Product Change Notification - SYST-21VMFE730

Notification subject: ERRATA - PIC18F24K20/25K20/44K20/45K20 Silicon Data Sheet Errata Errata Document Revision

PIC18F24K20/25K20/44K20/45K20

Silicon Errata and Data Sheet Clarification

1. Module: Dimensions for UQFN Packaging Option

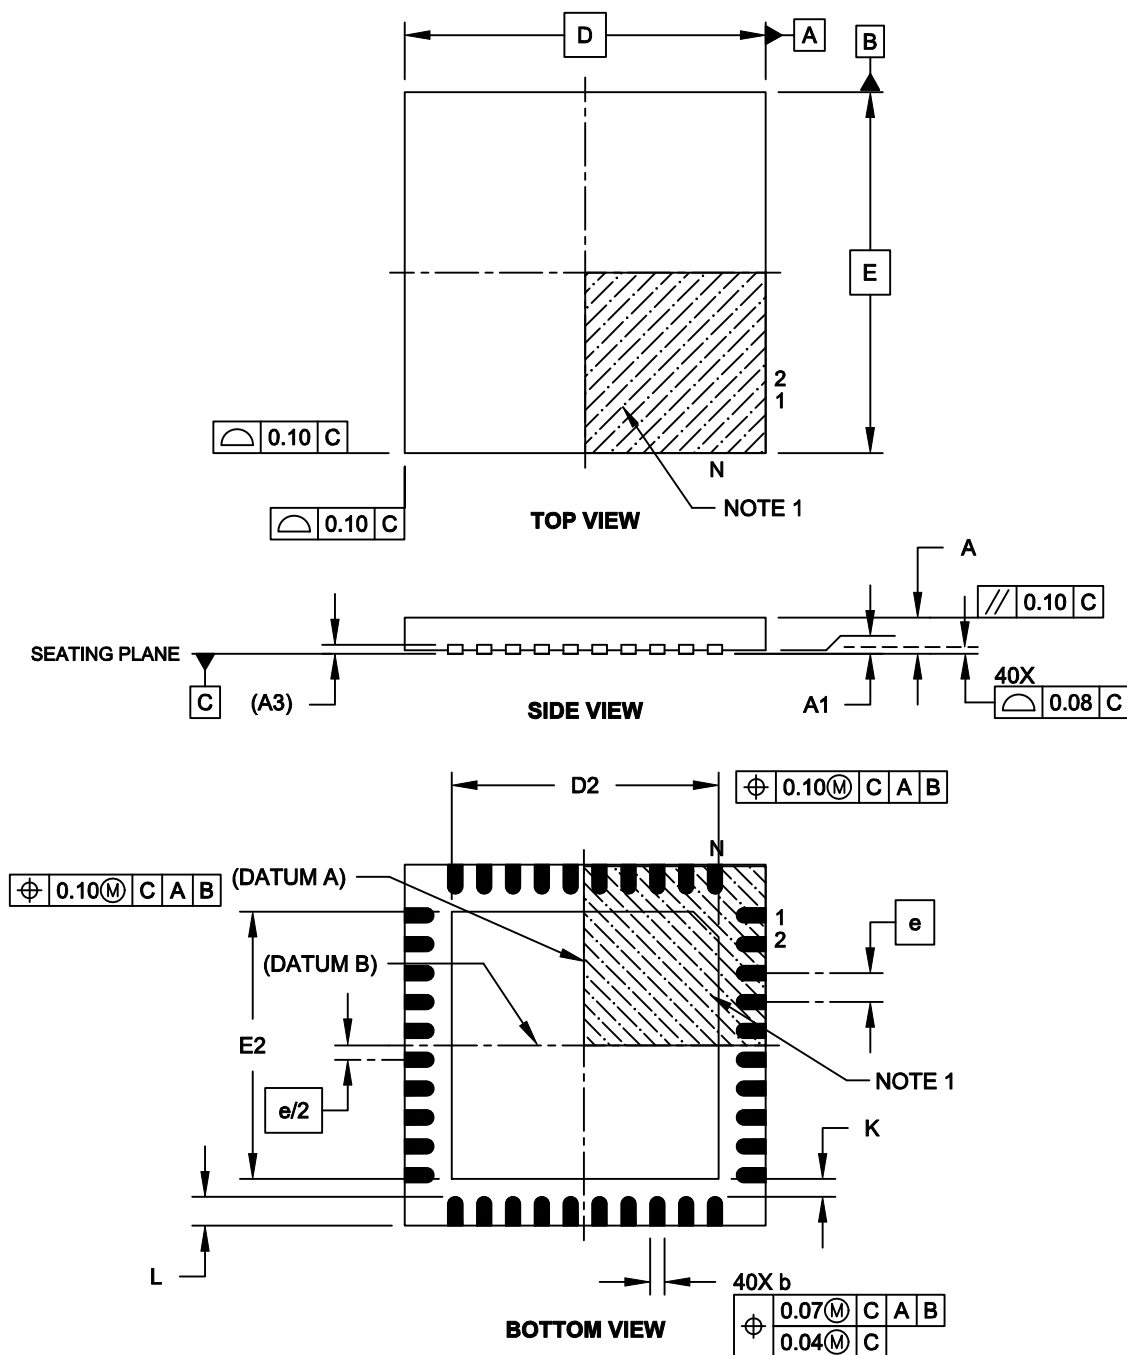
40-Lead Ultra Thin Plastic Quad Flat, No Lead Package (MV) – 5x5x0.5 mm Body [UQFN]

Note: For the most current package drawings, please see the Microchip Packaging Specification located at <http://www.microchip.com/packaging>

Microchip Technology Drawing C04-156A Sheet 2 of 2

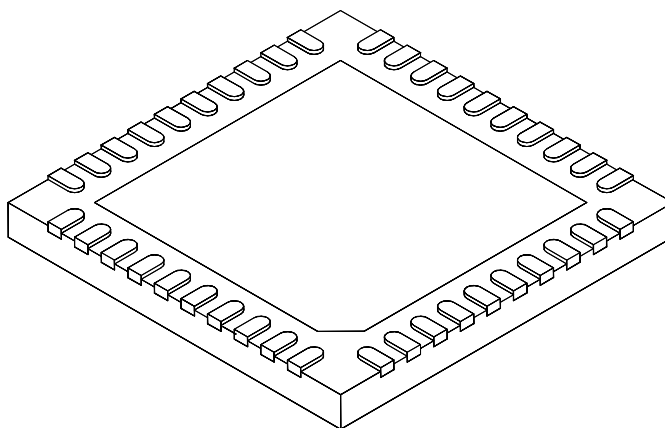
40-Lead Ultra Thin Plastic Quad Flat, No Lead Package (MV) – 5x5x0.5 mm Body [UQFN]
